North Central Texas
Council of Governments

**Recommended Amendments to the
2021 International Residential Code**
North Central Texas Council of Governments Region

The following sections, paragraphs, and sentences of the *2021 International Residential Code* are hereby amended as follows: Standard type is text from the IRC. Underlined type is text inserted. ~~Lined through type is deleted text from IRC.~~ A double asterisk at the beginning of a section identifies an amendment carried over from the 2018 edition of the code and a triple asterisk identifies a new or revised amendment with the 2021 code.

*****Section 307.2.2.2 ; add to read as follows**

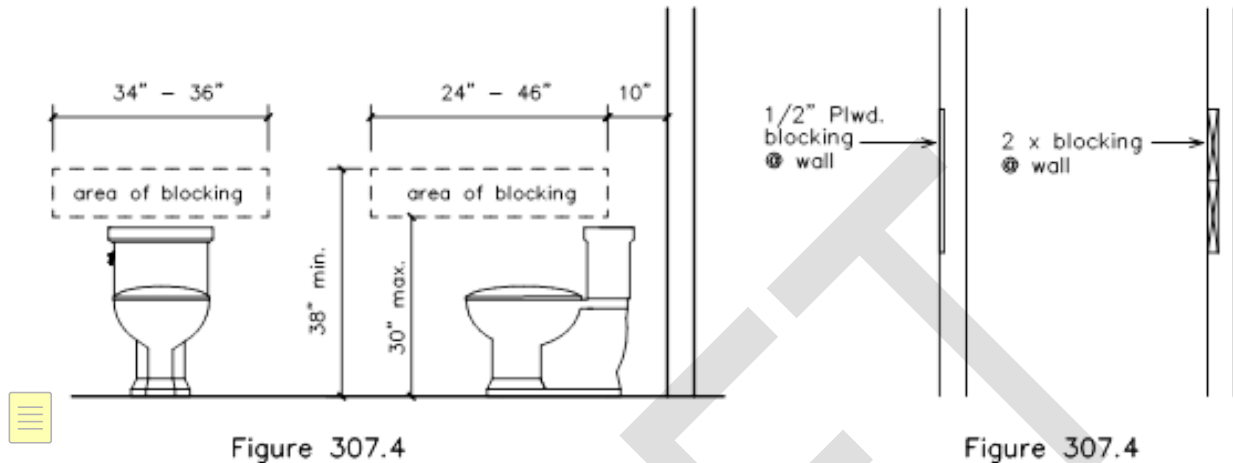
Section 307.2.2.2 Location. Depth of the swimming pool and spa shall maintain a ratio of 1:1 from the nearest building foundation or footing of a retaining wall. up to a maximum depth distance of 5'-0" (i.e. for a depth of 5'-0" the pool must be located 5'-0" from the nearest foundation) otherwise

Exception: a sealed engineered design drawing of the proposed new structure shall be submitted for approval is required

(Reason: Some pool installations are in close proximity to an existing foundation which can cause a structural failure leading to warranty claim issues for homeowners and builders. Several area cities currently utilize this proposed amendment as an amendment or SOP policy.)

****Figure R602.6.1; delete the figure and insert the following figure:**

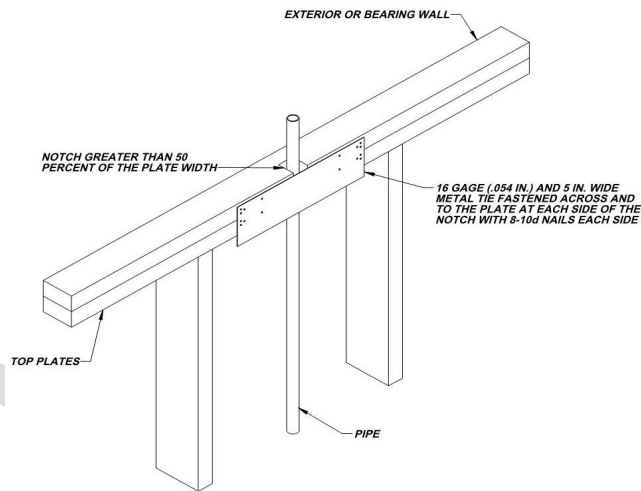
R602.6.1 Drilling and notching of top plate. When piping or ductwork is placed in or partly in an exterior wall or interior load-bearing wall, necessitating cutting, drilling or notching of the top plate by more than 50 percent of its width, a galvanized metal tie not less than 0.054 inch thick (1.37 mm) (16 Ga) and ~~4 1/2 inches (38) mm~~ 5 inches (127 mm) wide shall be fastened across and to the plate at each side of the opening with not less than eight 10d (0.148 inch diameter) having a minimum length of 1 1/2 inches (38 mm) at each side or equivalent. Fasteners will be offset to prevent splitting of the top plate material. The metal tie must extend a minimum of 6 inches past the opening. See figure R602.6.1. {remainder unchanged}

(Amendment to 2015 IRC carried forward to 2018 IRC also provides additional assurance of maintaining the integrity of the framing by spreading the nailing pattern.)
